Wednesday, February 2, 2022
Planning Commission

Planning Commission Agenda

Subject **A. CONSTRUCTION STANDARDS 22-01. Proposed amendments to Policy 4.39 of the Construction Standards.**

To: Mayor and City Council
From: Chris Thompson P.E., Public Works Director
Date: February 15, 2022
Re: Ordinance Construction Standards Revision (22.01)

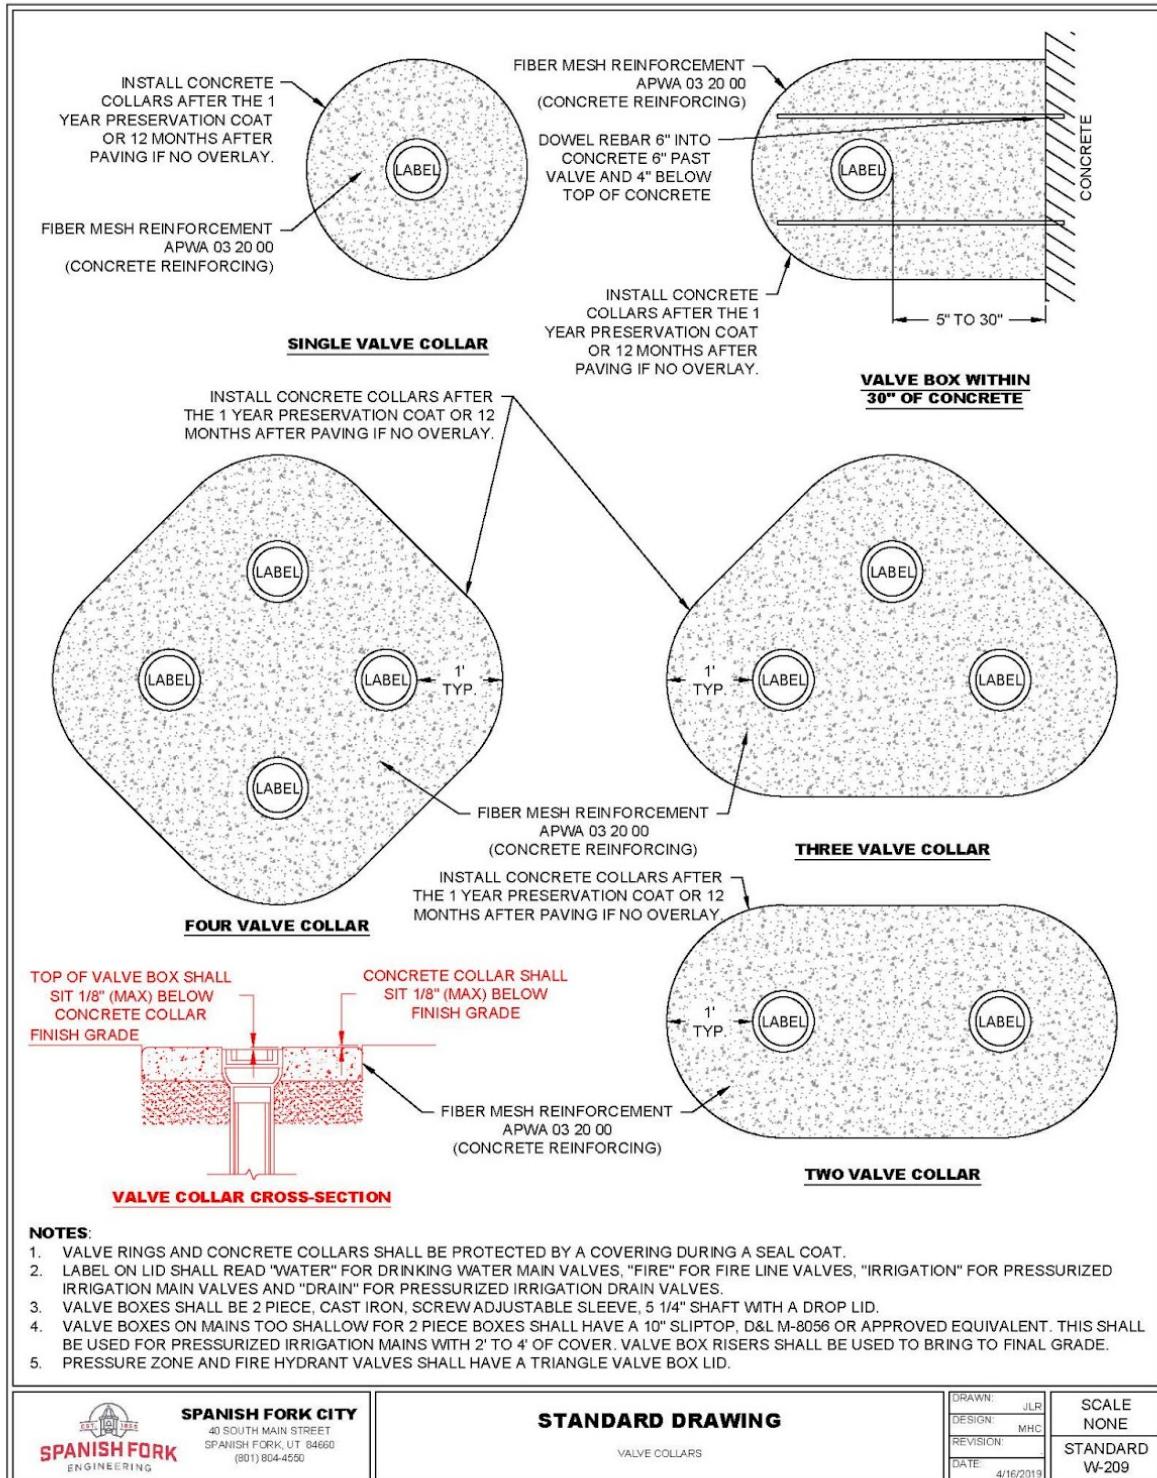
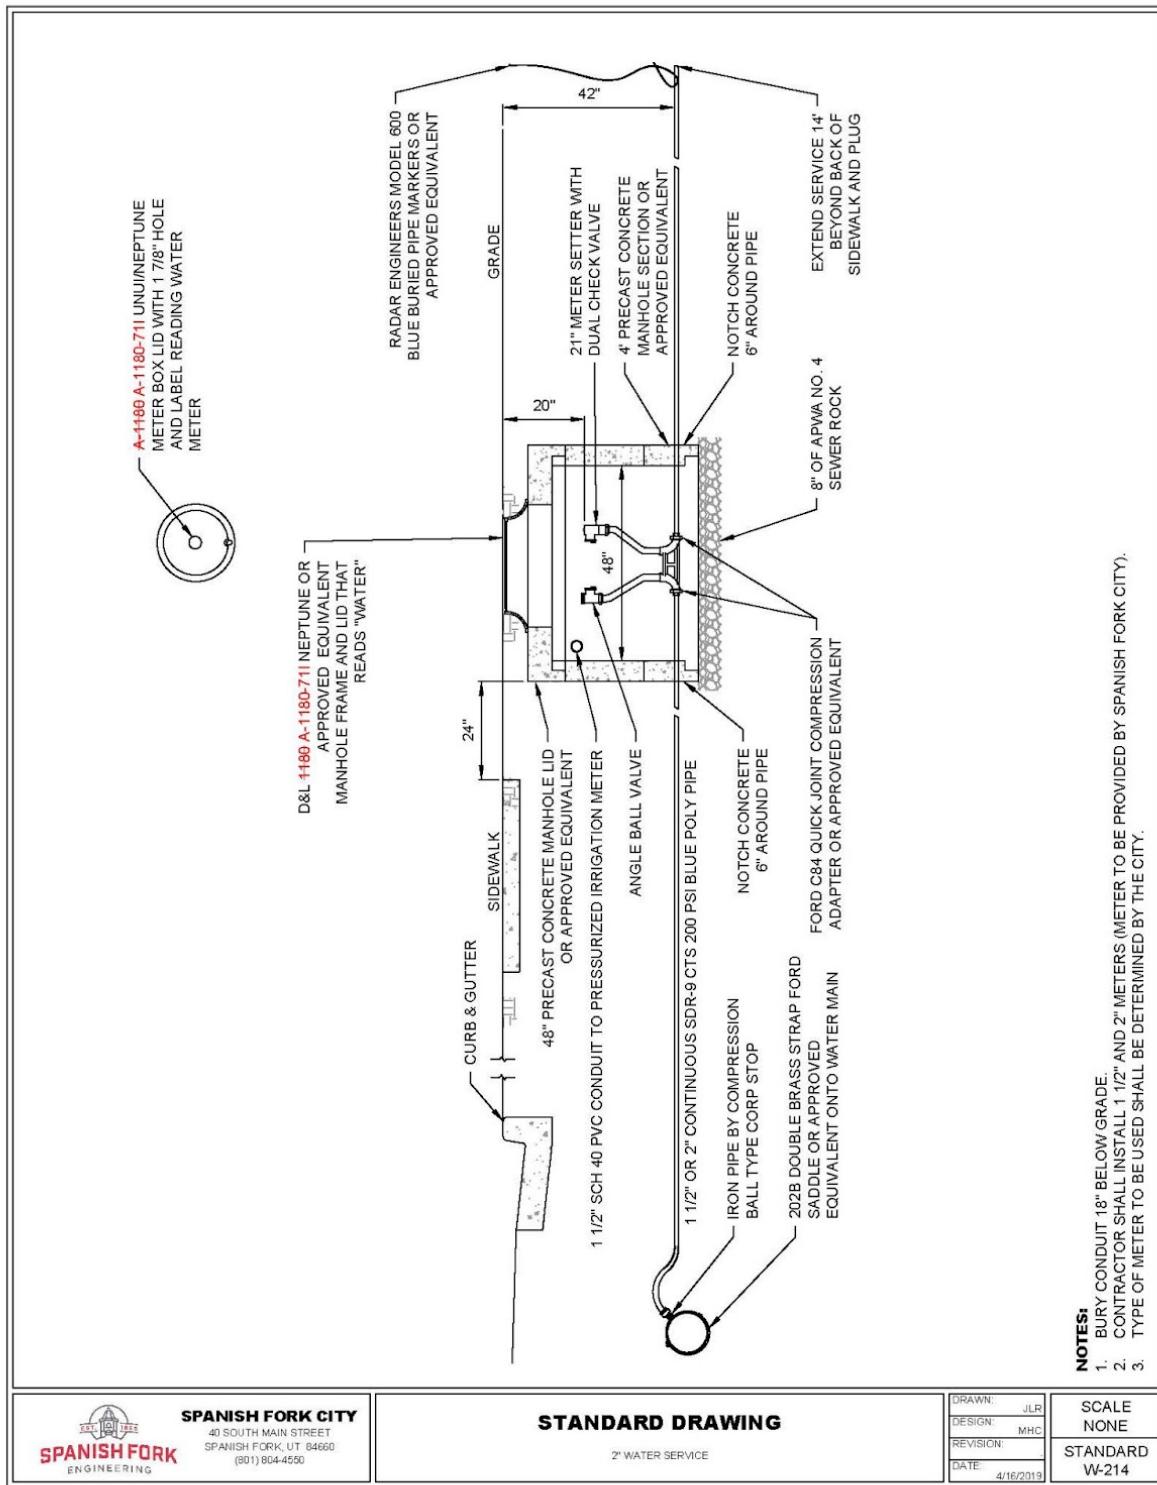
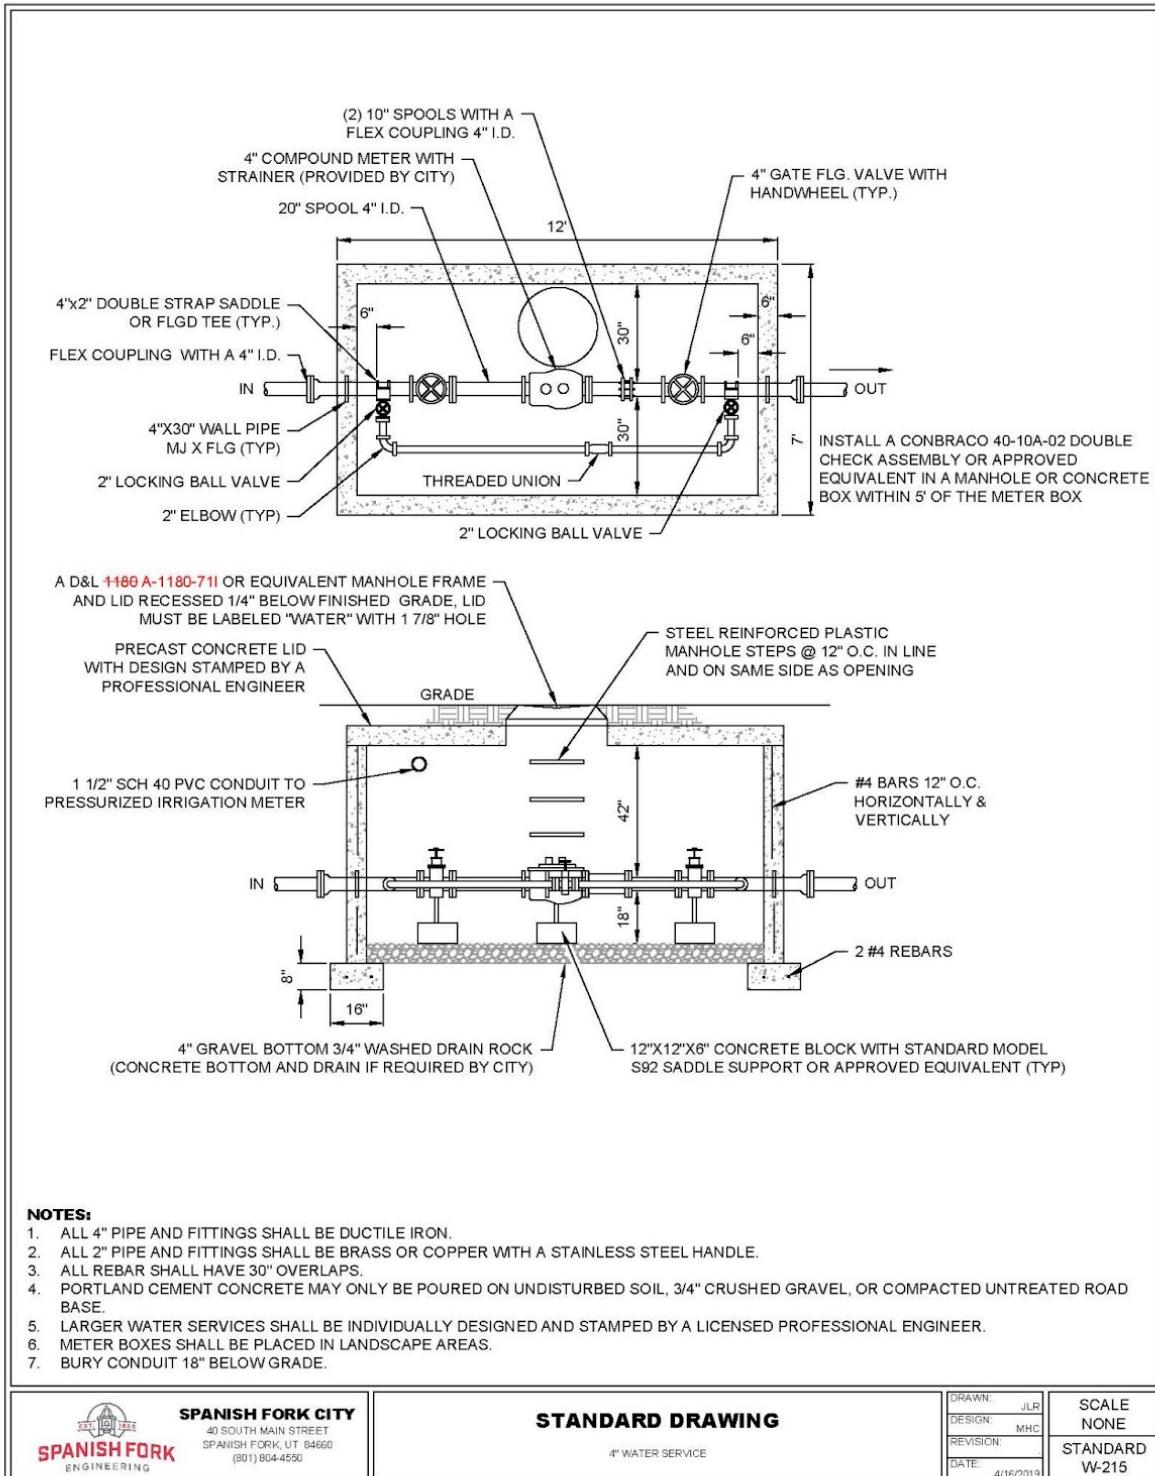
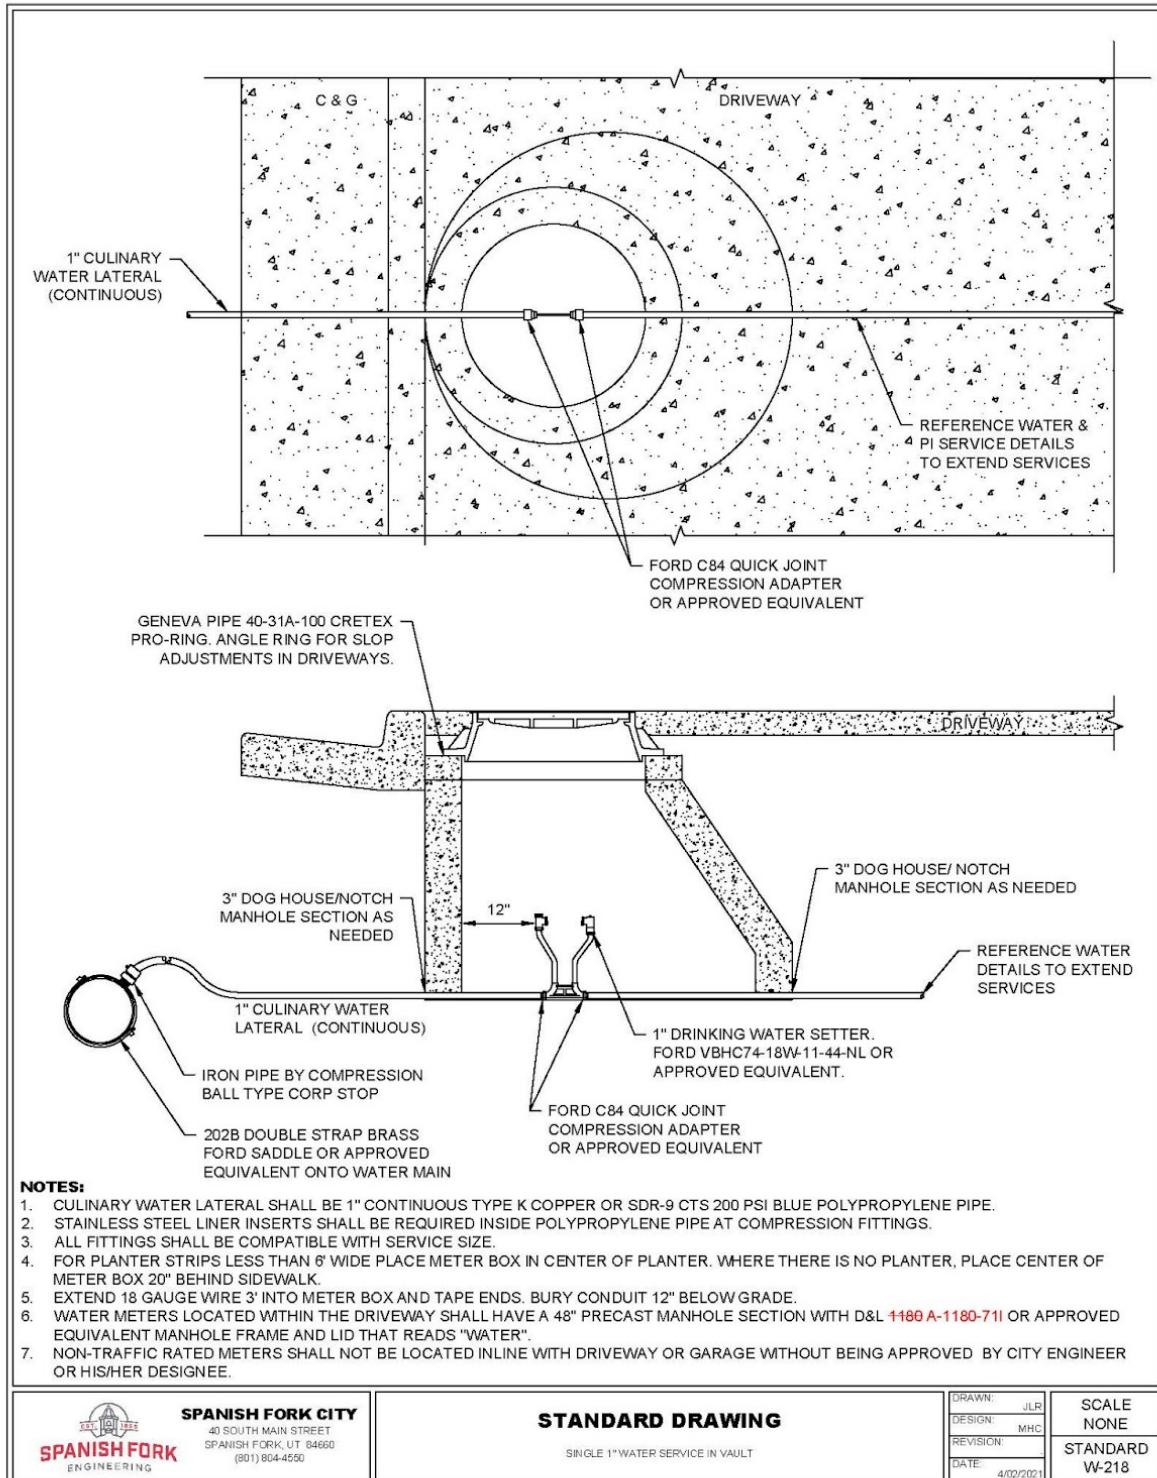
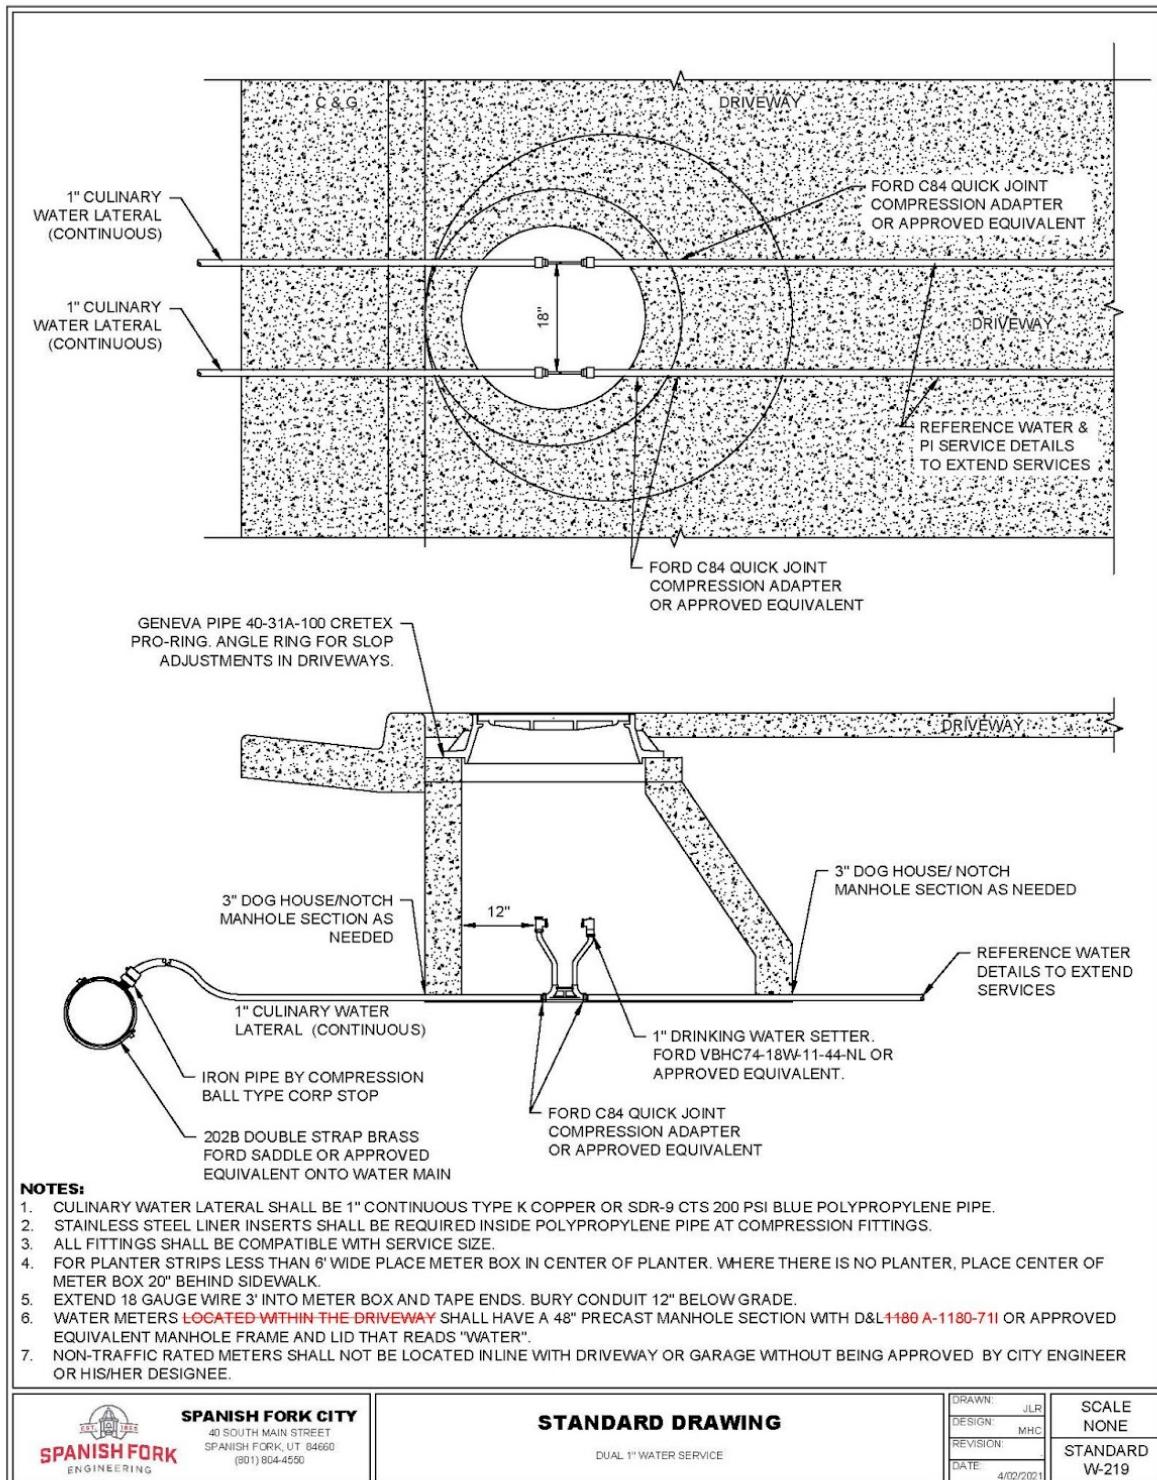
- Modifies standards W-214, W-215, W-218, W-219 & W-222 to call out the correct manhole lid.
- Modifies Concrete Collar to read $\frac{1}{8}$ " (max) instead of $\frac{1}{4}$ "
